Project	IEEE 802.16 Broadband Wireless Access Working Group < http://ieee802.org/16 >	
Title	MBS Harmonization - Harmonization Ad-Hoc Consensus DRAFT	
Date Submitted	2004-08-30	
Source(s)	Yong Chang, Geun Hwi Lim, B.S.Bae, D.K.Kim Samsung Electronic, Suwon P.O.Box 105, 416, Maetan-3dong, Paldal-gu, Suwon-si,Gyeonggi-do, Korea 442-742	yongchang@samsung.com
	Yongjoo Tcha, Sangho Yi, Seong-Choon Lee KT, 17 Woomyeon-dong, Seocho-gu, Seoul, 137- 792, Korea	yjtcha@kt.co.kr
	Chulsik Yoon ETRI	csyoon@etri.re.kr
	Ronny (Yong-Ho) Kim, Kiseon Ryu, BJ Kim, and Changjae Lee LG Electronics,Inc. 533,Hogye-1dong,Dongan-gu, Anyang-shi,Kyongki-do, Korea	[ronnykim,ksryu,beom,cjlee16]@lge.com
	Yigal Leiba Runcom Technologies Ltd. Hacoma 2, Rishon LeZion, Israel	yigall@runcom.co.il
	Yigal Eliaspur Penny Efraim Sagi, Sharon Ben-Porath Intel Corporation	yigal.eliaspur@intel.com
	Jeff Mandin Streetwaves Networking Amatzia 5 Jerusalem, Israel	Voice: 972-50-724-587 Fax: 972-50-724-587 mailto:jeff@streetwaves-networks.com

MBS Harmonization

Figure 1: Example of MBS service scenario

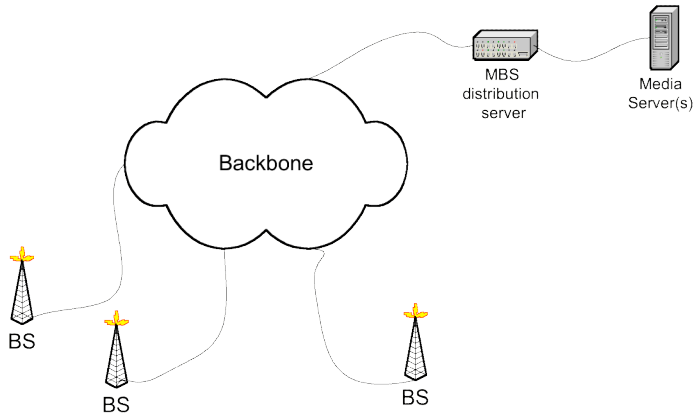
Originally, Runcom proposes the MBS operation reference model in Contribution C80216e-04_275.doc with the following reasons.

- BS must perform synchronized transmissions of the multimedia traffic to achieve the macro-diversity effect at the MSS
 - ← This requires all BS in the same multimedia broadcast (MBS) to transmit a synchronized PDU stream. Some means for synchronizing SDU distribution, conversion to PDUs, and any process that changes the PDU transmission over the air must be the same for all the BS in the same MBS zone
 - ← The 802.16e reference model and standard must be accordingly updated to support a centralized data transmitter that performs data scheduling for simultaneous, identical, transmissions over multiple Base Stations

Figure 2: MBS operation reference model

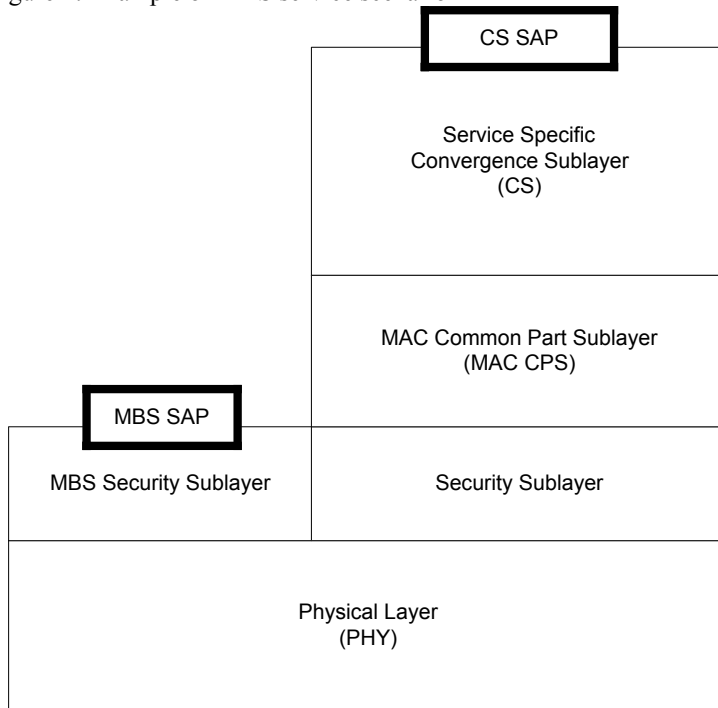
We add an MBS Distribution Server entity to the reference model. An MBS Distribution Server is a generic entity responsible for scheduling of data across multiple Base Stations and distributing the MBS stream. An MBS SAP resides above the security sublayer – as classification and scheduling services are not performed for the MBS-controlled flows.

Each BS participating in the MBS zone "outsources" the scheduling and PDU building functions for the MBS zone data interval to the MBS distribution server. The MBS Server supplies the transmittable data and timing information to each BS to transmit directly over the PHY.
